Response to

Request for Additional Information No. 34, Revision 0

U. S. EPR Standard Design Certification

Docket No. 52-020

Figure 15.02.08-11-1—FWLB Maximum RCS Pressure Case – Vapor Void Fraction at the Break

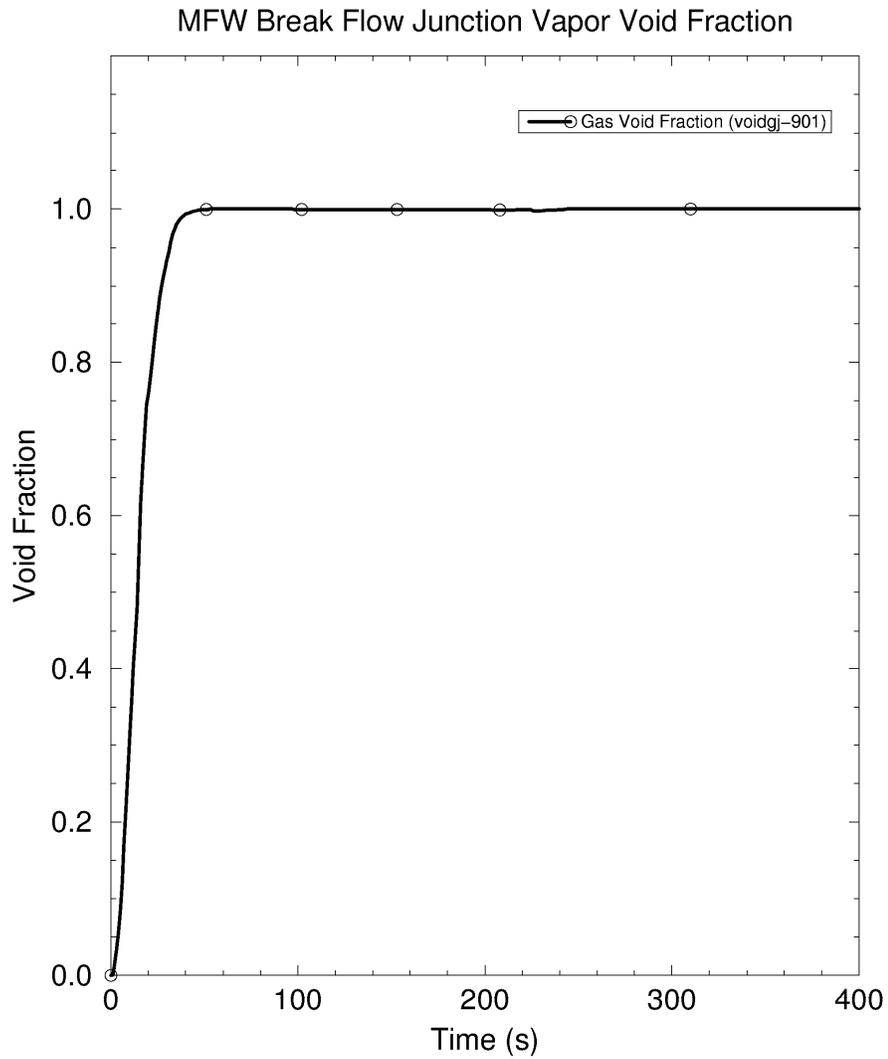
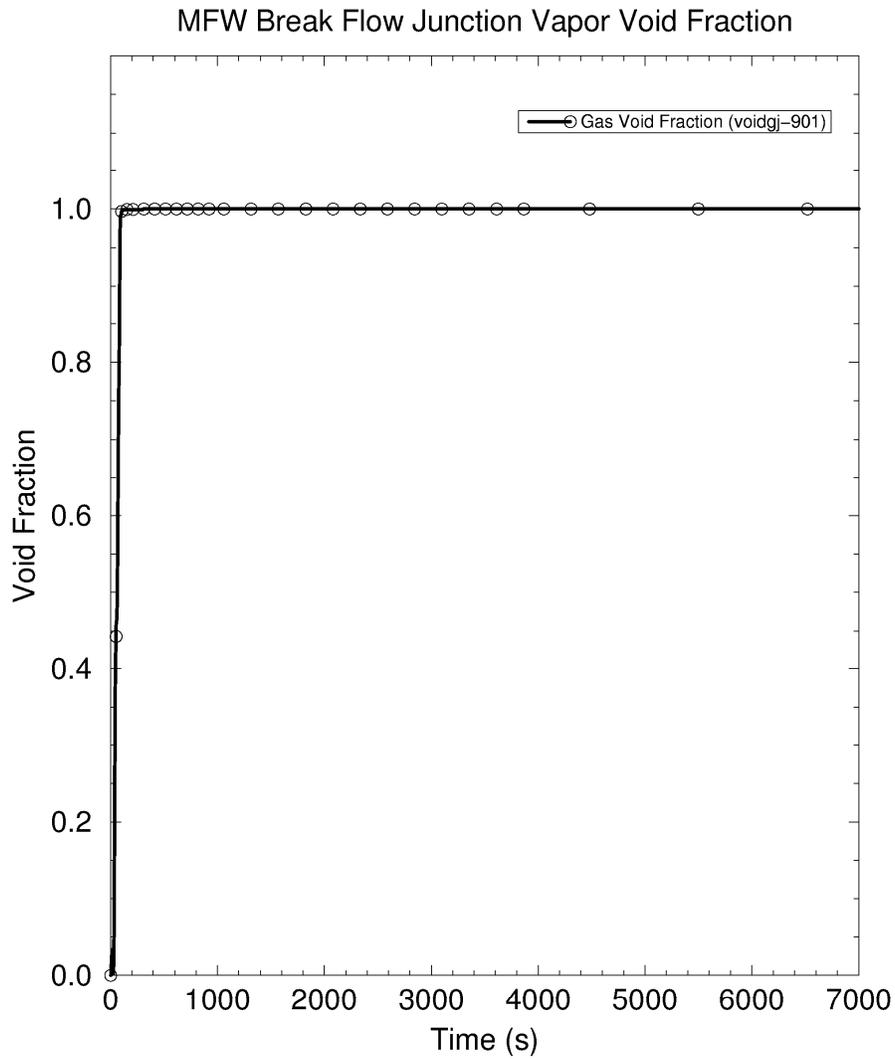
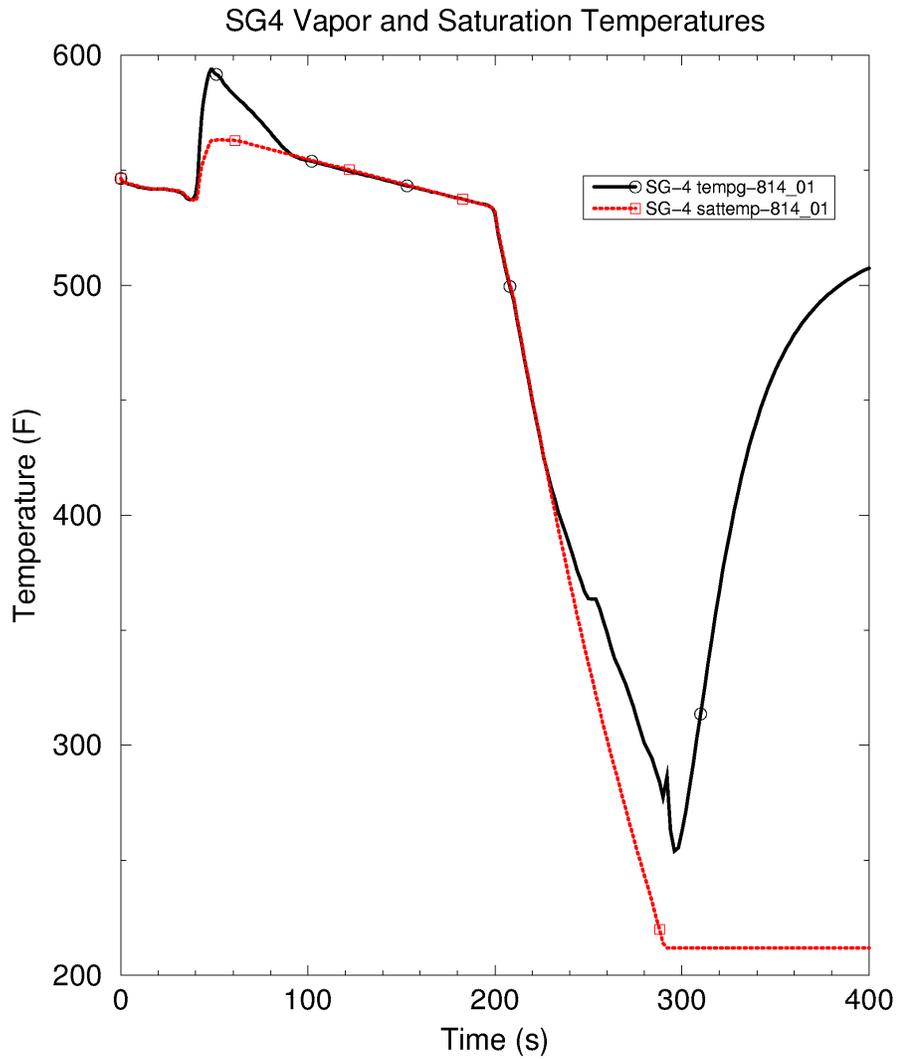
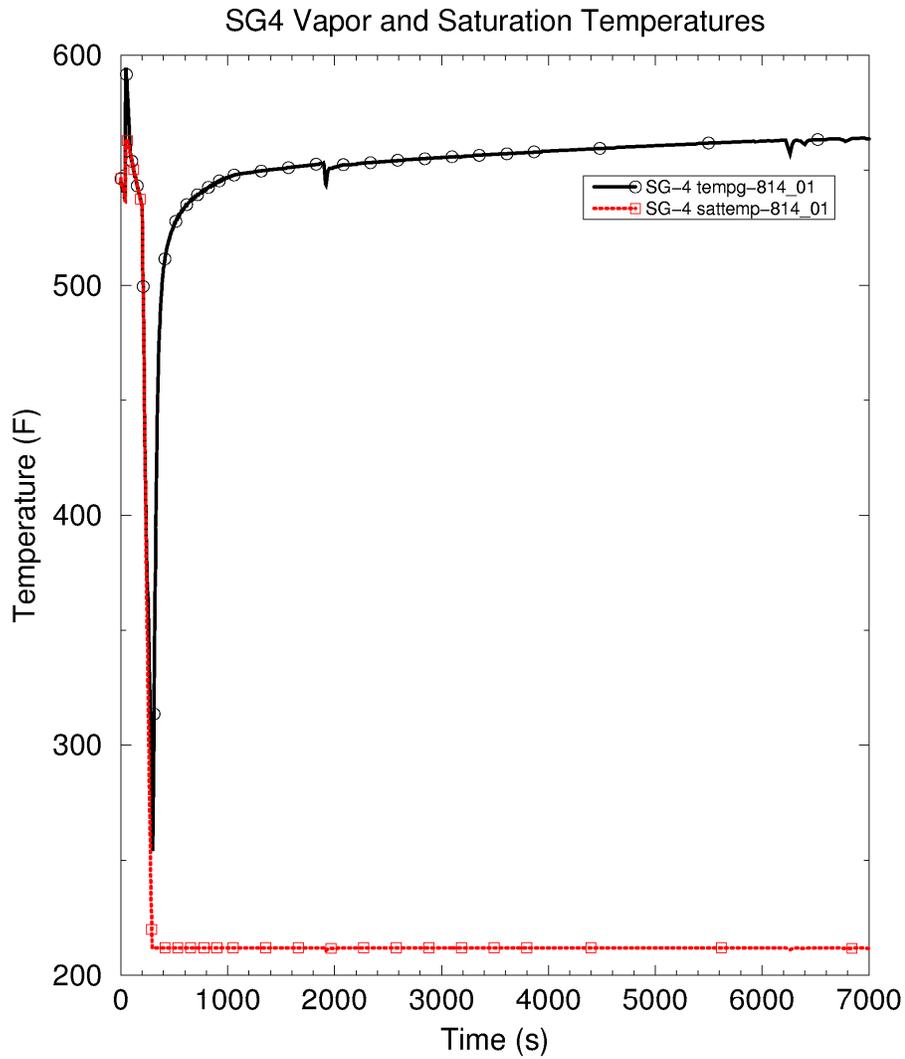
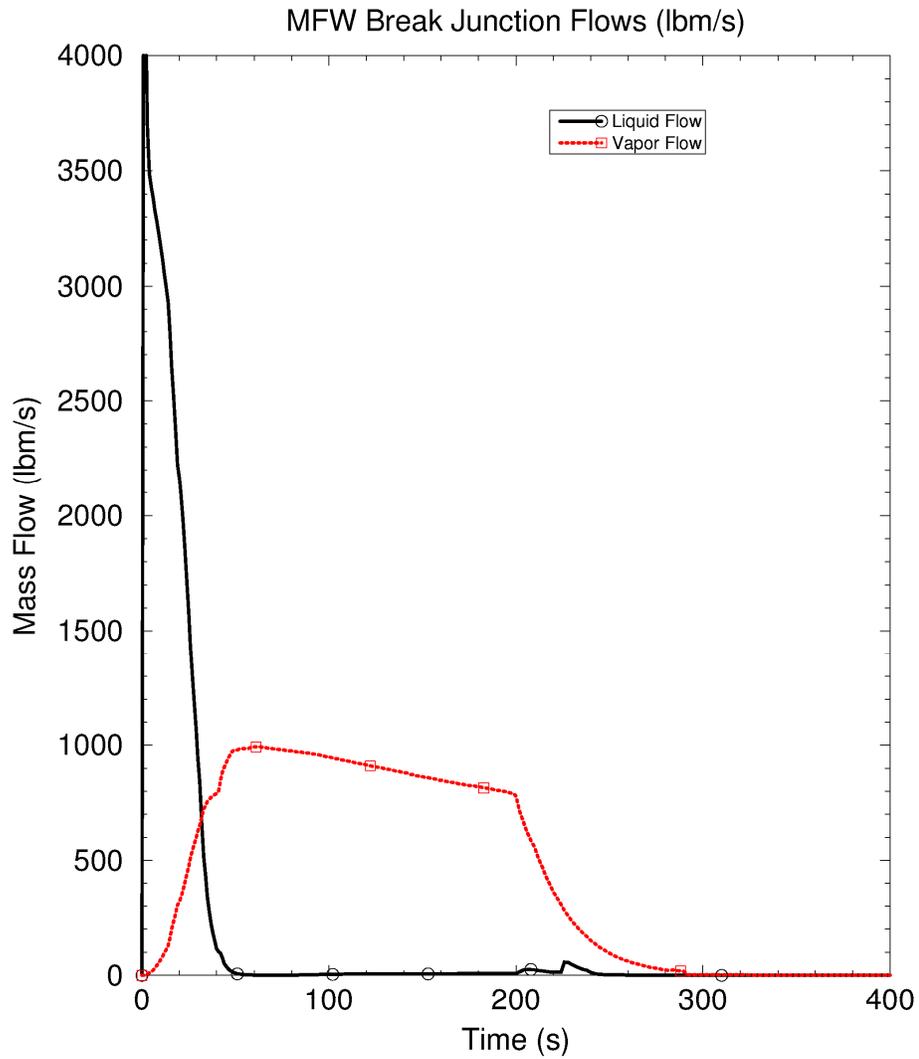
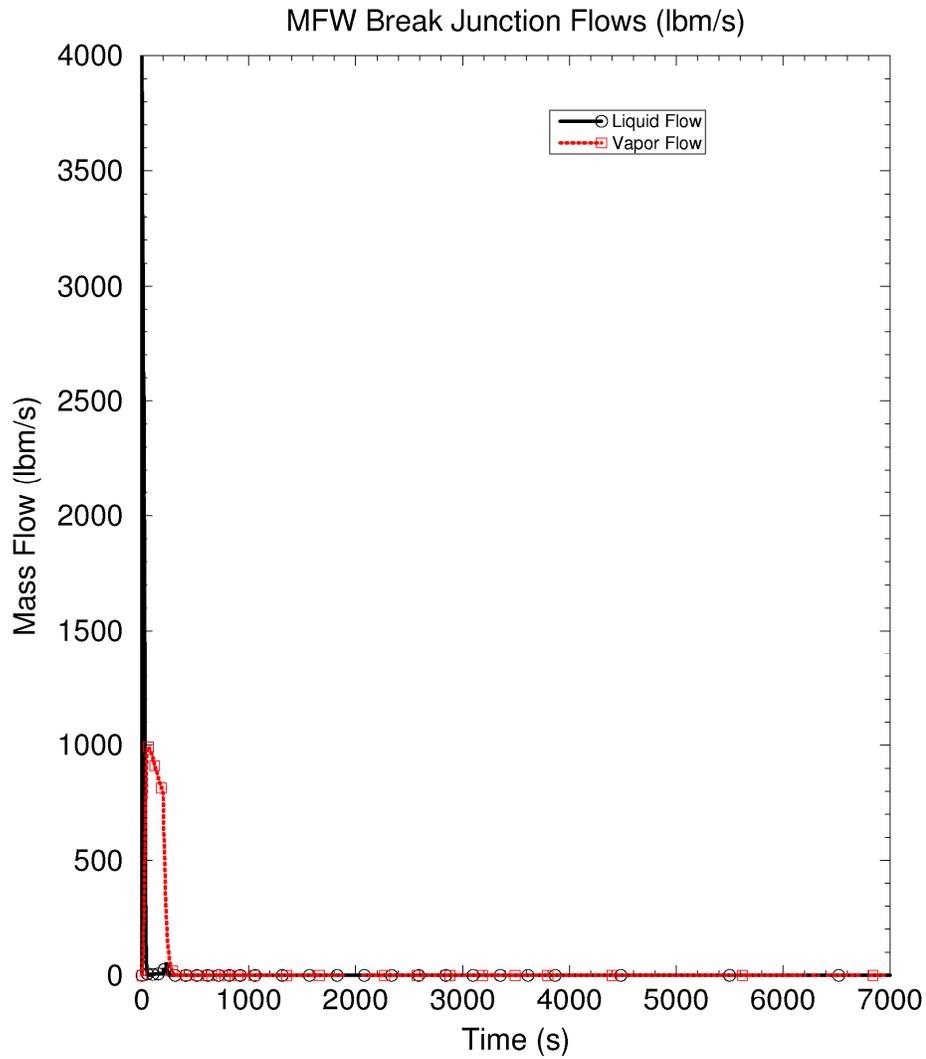
For the break flow in Figure 15.2-77 "FWLB Maximum RCS Pressure Case – Break Flow" explain how the break flow area was determined. Please explain the criterion used for determining the worst break size. Demonstrate that it produces the highest peak RCS pressure. Provide the flow quality as well as the fluid-phase temperatures at the break opening. In addition, provide the liquid- and vapor-phase mass flow rate at the break and specify the break backpressure used in the calculations. Use a logarithmic scale over an appropriate range in displaying quantities that vary significantly in magnitude (15.2.8 Section III).

The void fraction at the break opening is provided in the attached Figure 15.02.08-11-1 (time scale to 400 seconds) and Figure 15.02.08-11-2 (time scale to 7000 seconds). The vapor phase temperature and saturation temperature in the break upstream volume are provided in the attached Figure 15.02.08-11-3 (time scale to 400 seconds) and Figure 15.02.08-11-4 (time scale to 7000 seconds). The liquid and vapor mass flows are provided in Figure 15.02.08-11-5 (time scale to 400 seconds) and Figure 15.02.08-11-6 (time scale to 7000 seconds).

**Figure 15.02.08-12-1—FWLB Maximum RCS Pressure Case – MSRCV
Normalized Valve Flow Area**

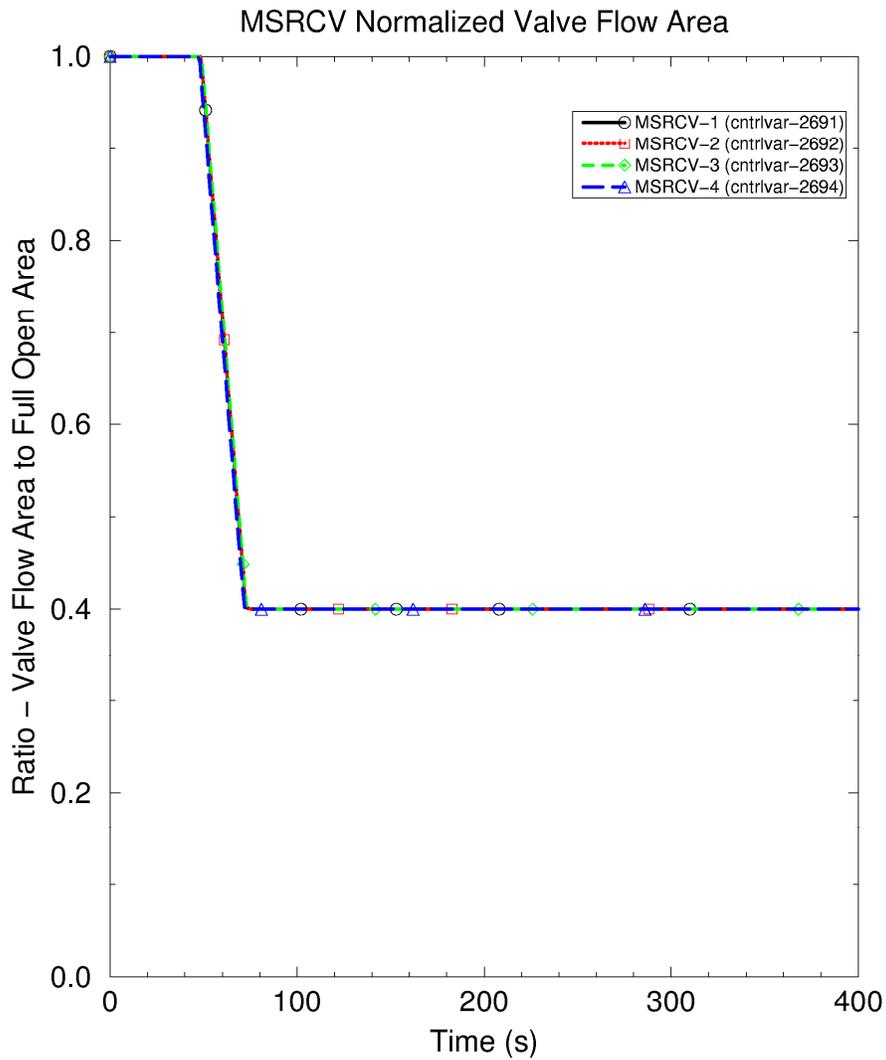
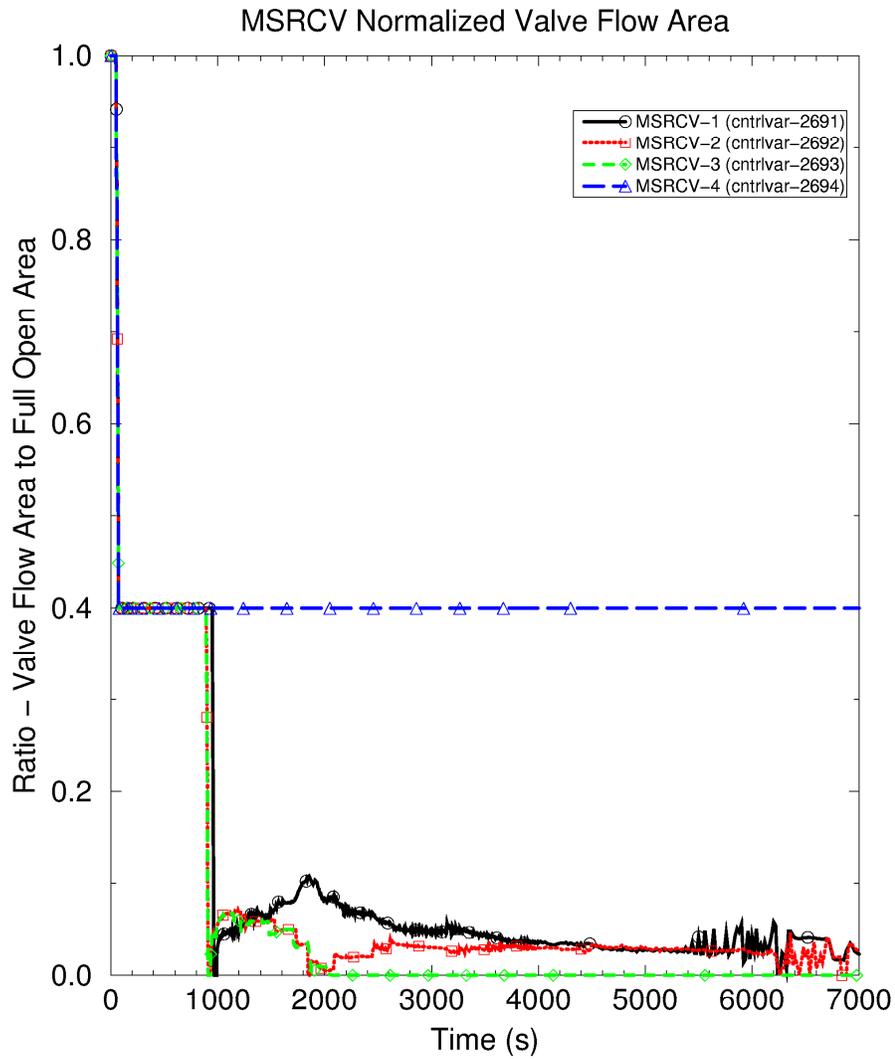
Provide the valve flow areas used to compute the mass flow rates shown in Figure 15.2-78 “FWLB Maximum RCS Pressure Case – Main Steam Relief Loops 1 and 2” and in Figure 15.2-79 “FWLB Maximum RCS Pressure Case – Main Steam Relief Loops 3 and 4” (15.2.8 Section III).

The normalized main steam relief control valve (MSRCV) flow areas are provided in Figure 15.02.08-12-1 (time scale to 400 seconds) and Figure 15.02.08-12-2 (time scale to 7000 seconds). The modeled valve full-open area for the normalization is 0.2598 ft². The main steam relief isolation valve (MSRIV) must also be opened for flow to occur in the main steam relief train (MSRT).

Figure 15.02.08-13-1—FWLB Maximum Secondary Pressure Case – MSRCV Normalized Valve Flow Area

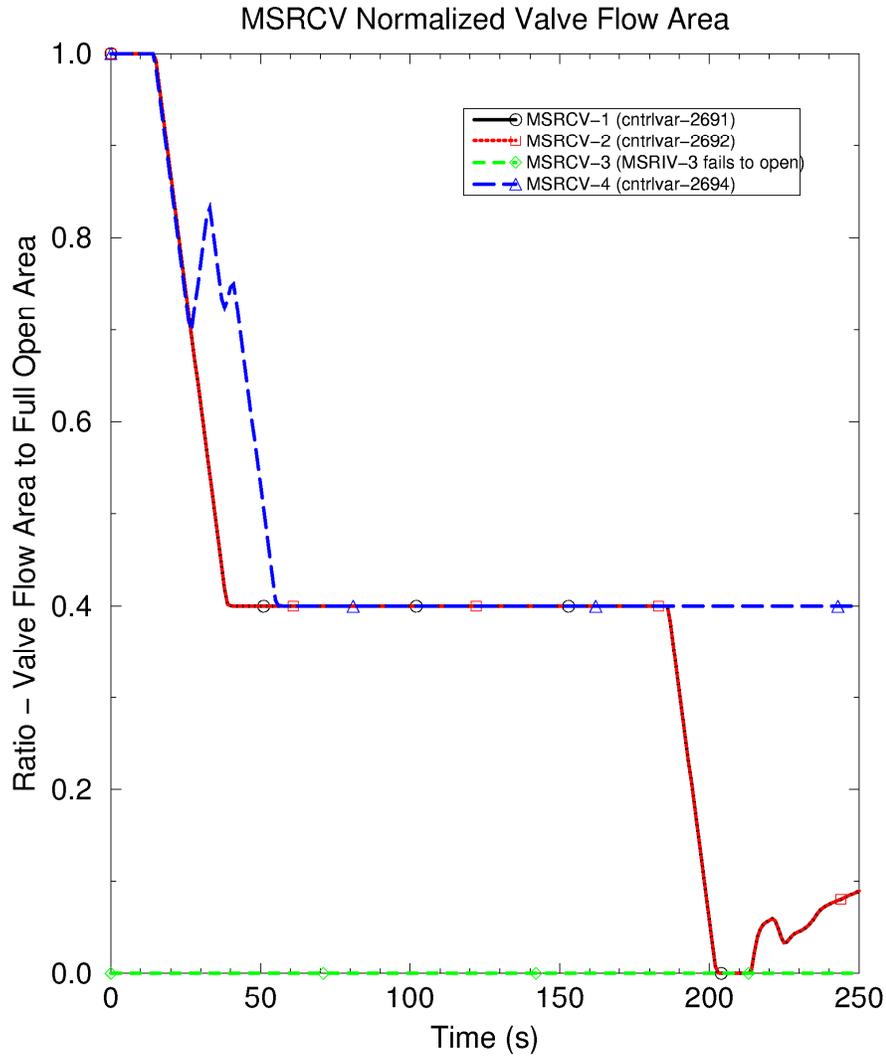
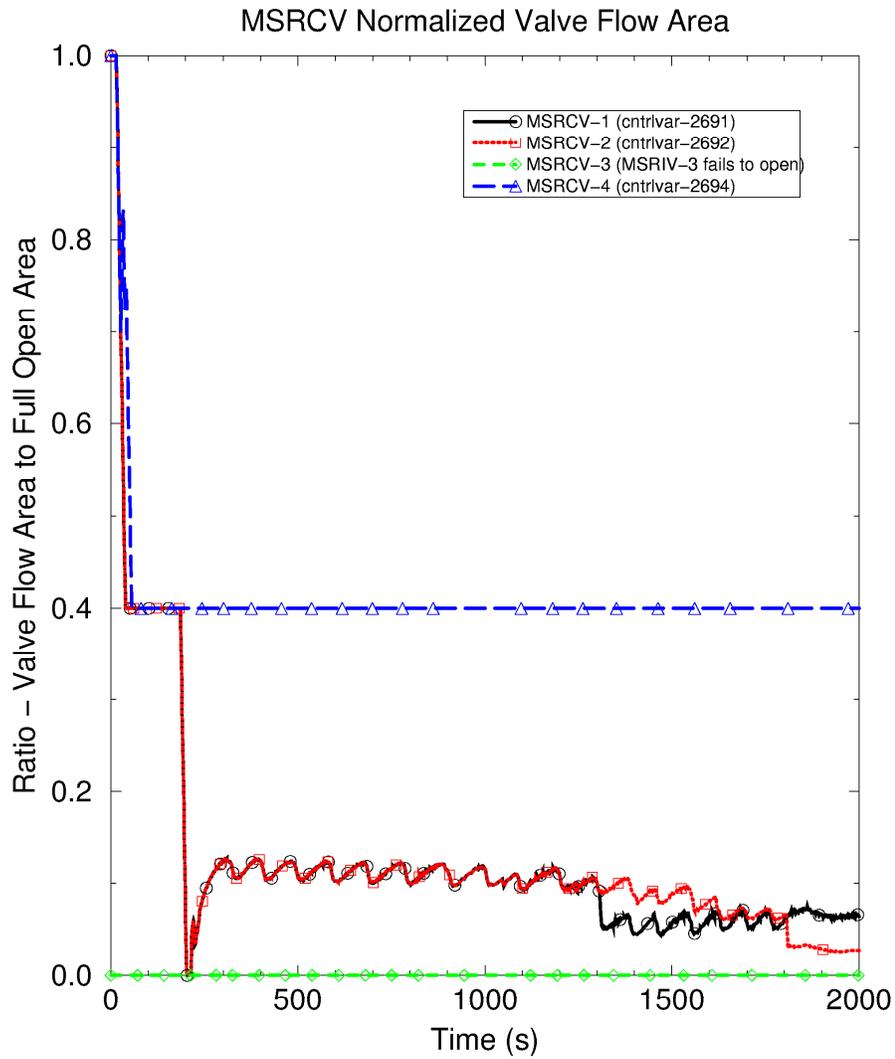
Provide the valve flow areas used to compute the mass flow rates shown in Figure 15.2-96 "FWLB Maximum Secondary Pressure Case – Main Steam Relief Loops 1 and 2" and in Figure 15.2-97 "FWLB Maximum Secondary Pressure Case – Main Steam Relief Loops 3 and 4" (15.2.8 Section III).

The normalized main steam relief control valve (MSRCV) flow areas are provided in Figure 15.02.08-13-1 (time scale to 250 seconds) and Figure 15.02.08-13-2 (time scale to 2000 seconds). The modeled valve full-open area for the normalization is 0.2598 ft². The main steam isolation valve (MSRIV) must also be opened for flow to occur in the main steam relief train (MSRT). MSRIV-3 (for steam generator 3) is assumed to fail to open for this case, so the MSRCV-3 position has no effect on the results.
